Parts Information

Series Buttonholing Machine

Model LBH-1790A Series

LBH-1796A: Newly-developed a feed auxiliary sheet

New part	
P/N	40162614	
Part name	FEED_SUPPORT_SHEET_B	
Reference		
Dimension	<p style="text-align: right;">Material : ABS t = 1.0</p>

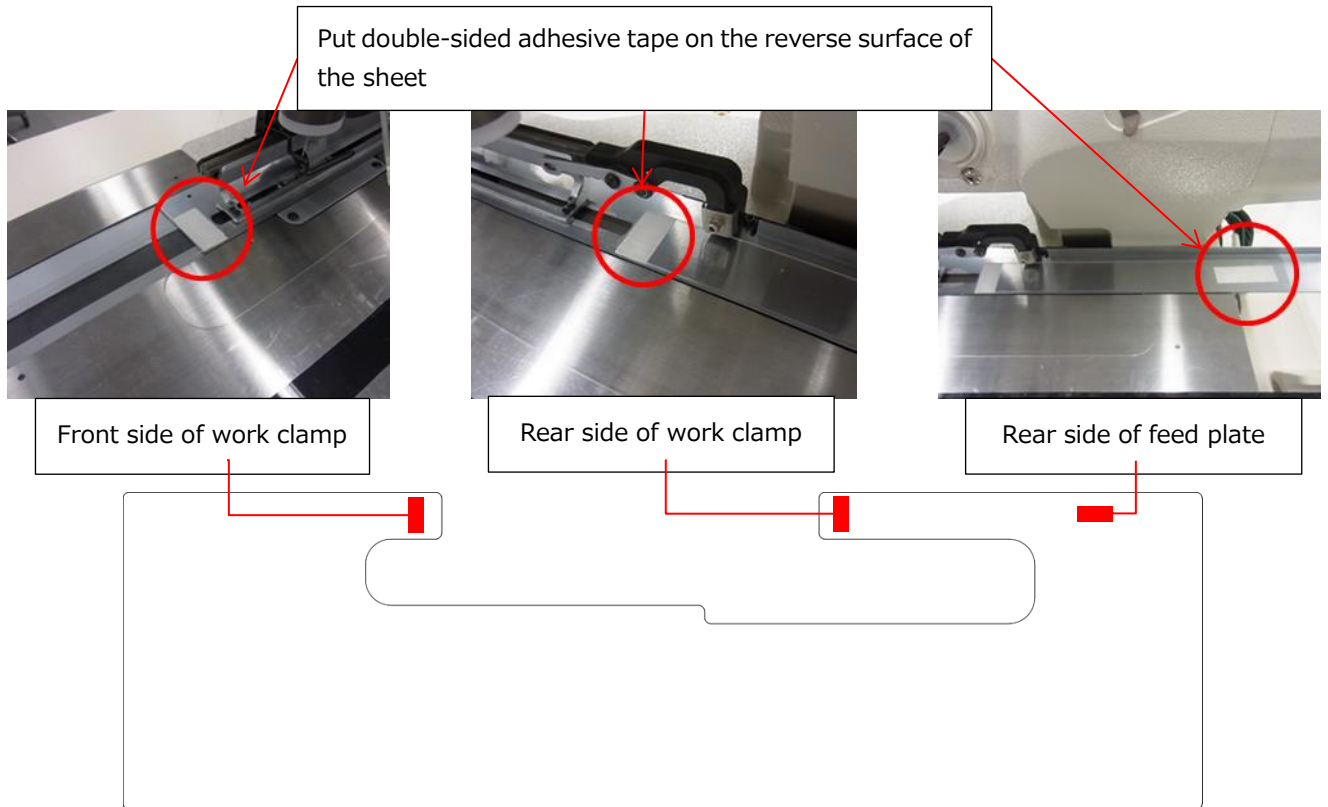
A new feed auxiliary sheet has been developed as an option for the LBH-1796A.

For the LBH-1796A, this new feed auxiliary sheet is effective when using a difficult-to-feed material or material slippage occurs.

When the optional feed auxiliary sheet is fixed on the feed plate with double-sided adhesive tape, top center plait and garment body are fed together, thereby preventing material slippage.

Put double-sided adhesive tape on the reverse surface of feed auxiliary sheet and fix the sheet on the feed plate.

The feed plate slides smoothly by putting the slide assisting tape (1 piece) (40044824) supplied with the machine as an accessory on the undersurface of the feed plate.
